ADMINISTRATIVE AMENDMENT

VISTA DEL NORTE COMMUNITY PARK

MASTER DEVELOPMENT PLAN / SITE PLAN FOR BUILDING PERMIT
SITE PLAN

VISTA DEL NORTE PARK - SITE PLAN AMENDMENT

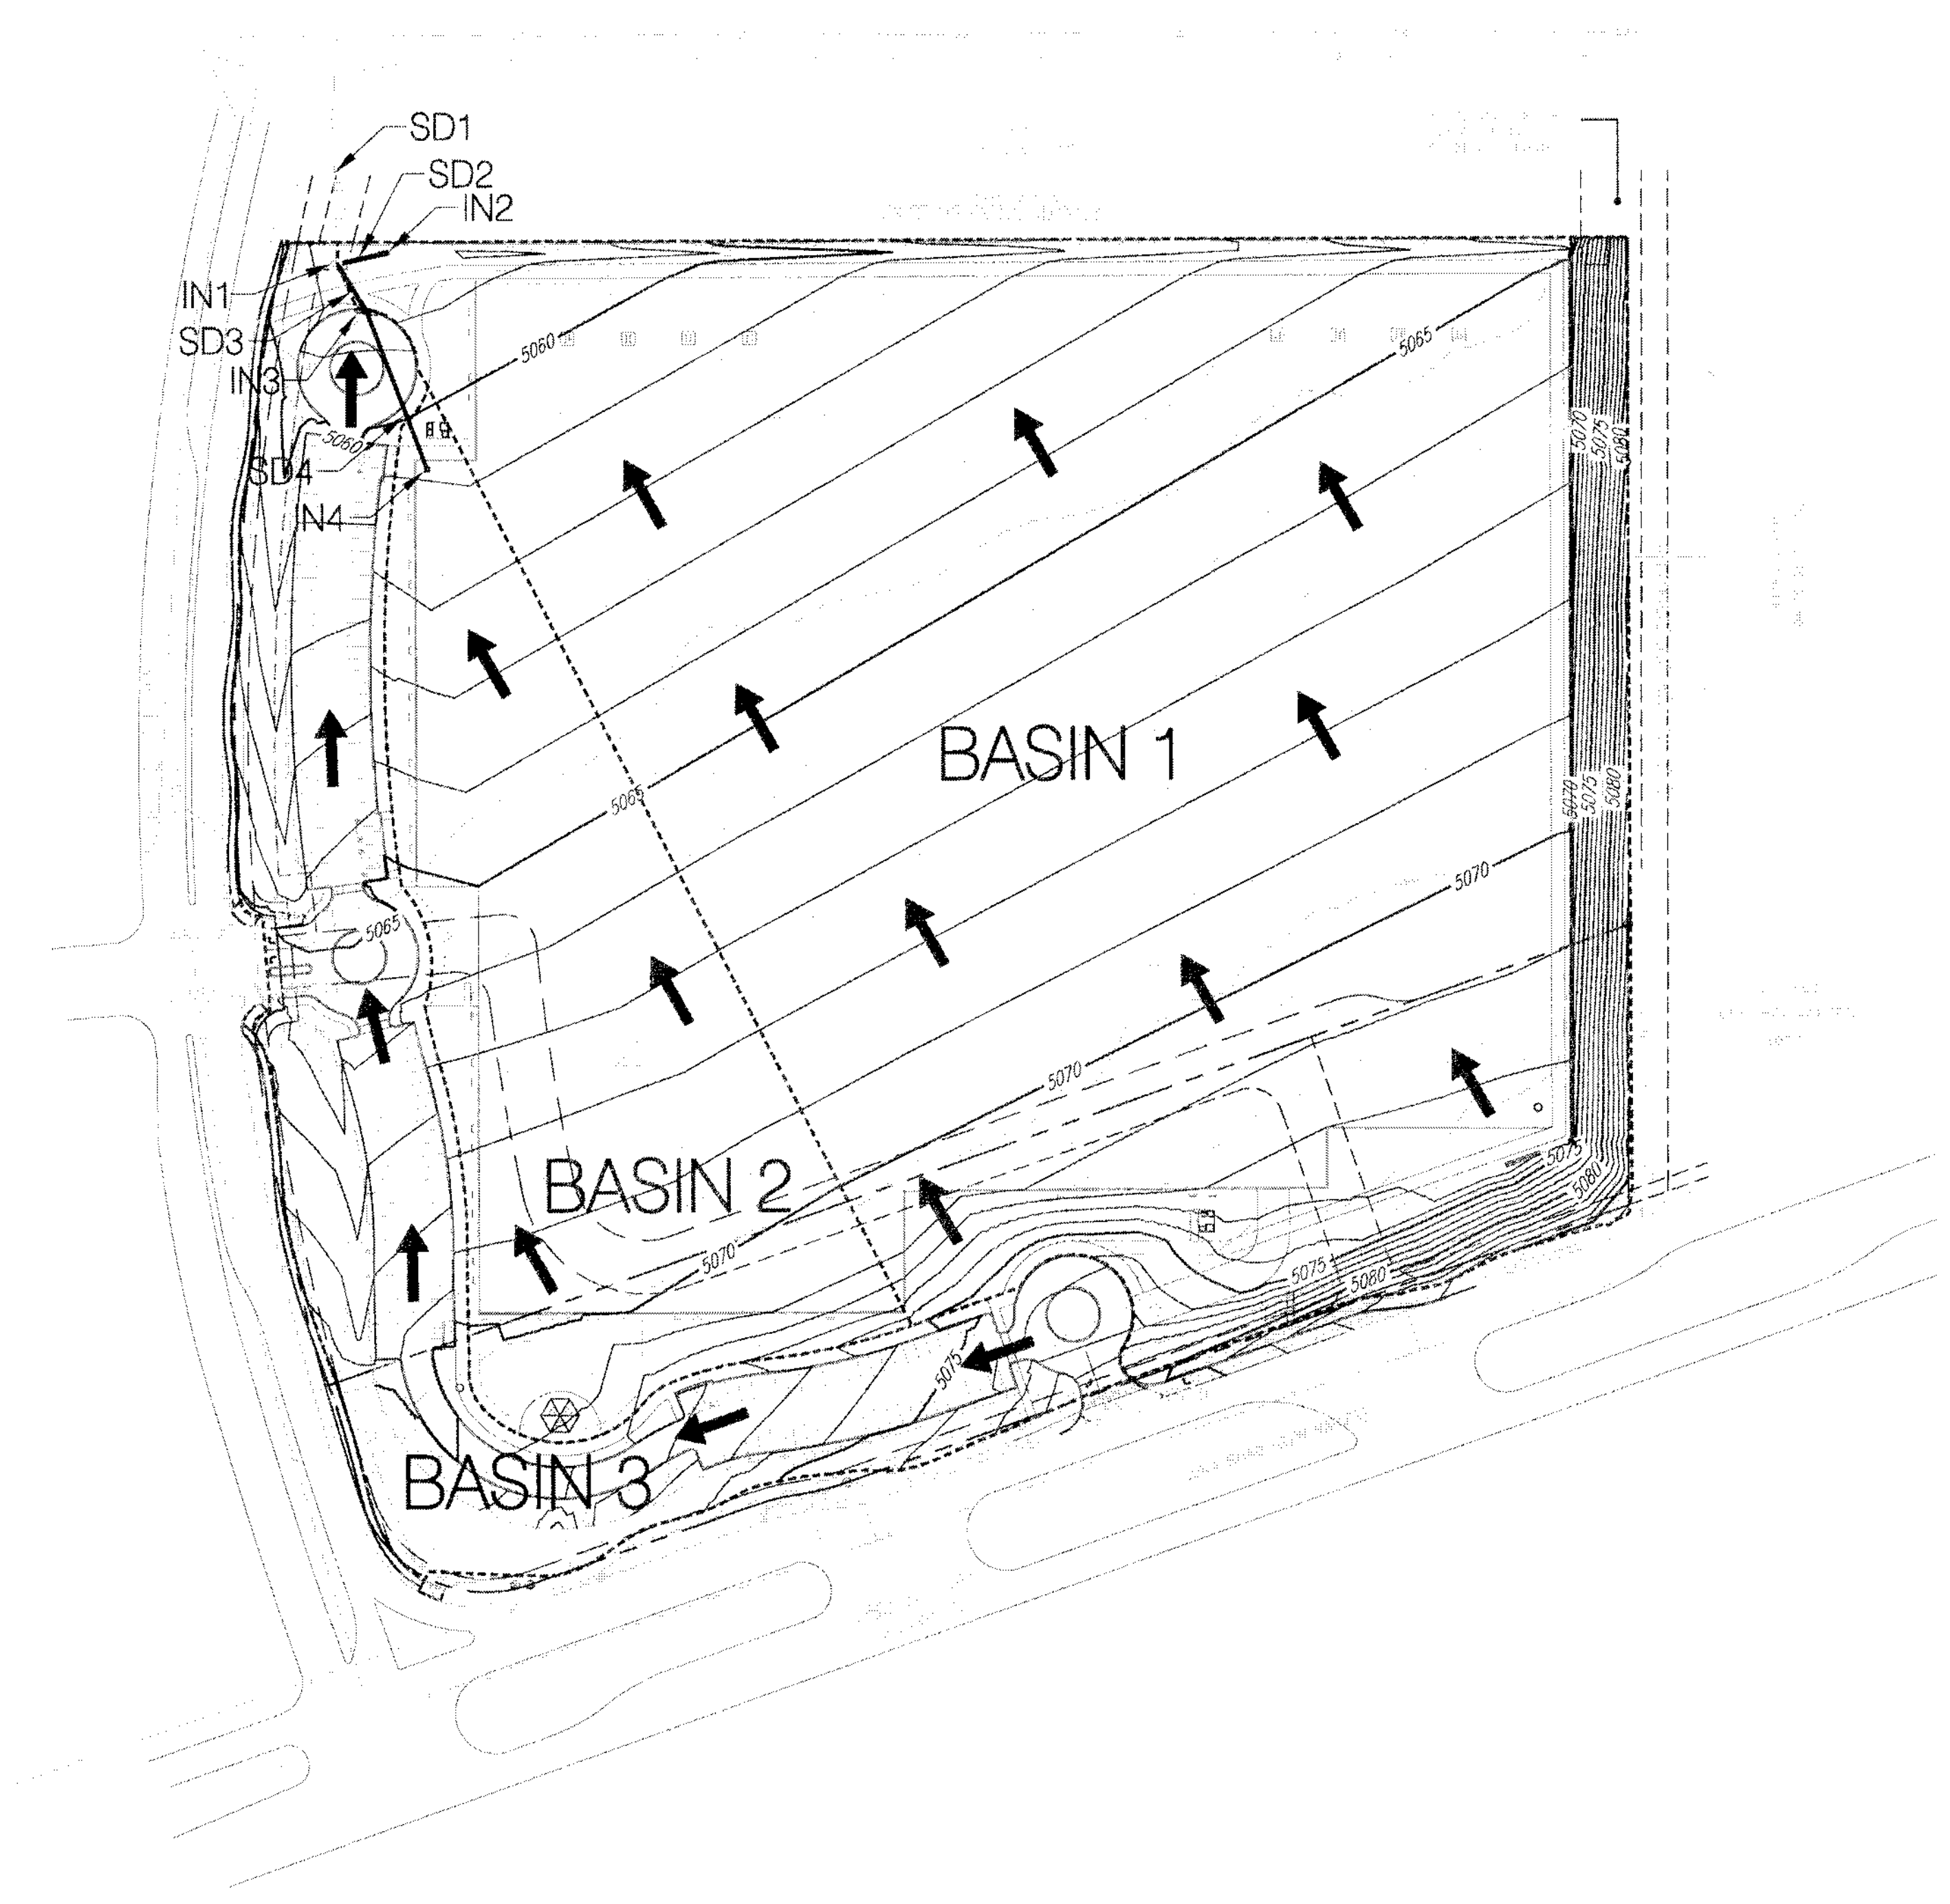
PROVIDE VAULT TOILET RESTROOM
BUILDING IN LIEU OF FENCED
PORTA-POTTY ENCLOSURE

NEW DOG PARK WITH FENCING,
METAL SHADE STRUCTURES, AND
SITE FURNISHINGS

PROVIDE VAULT TOILET RESTROOM
BUILDING IN LIEU OF FENCED
PORTA-POTTY ENCLOSURE

ADDITIONAL PAVED
PARKING LOT (177 SPACES)

NATURE PLAY AREA AND SEATING
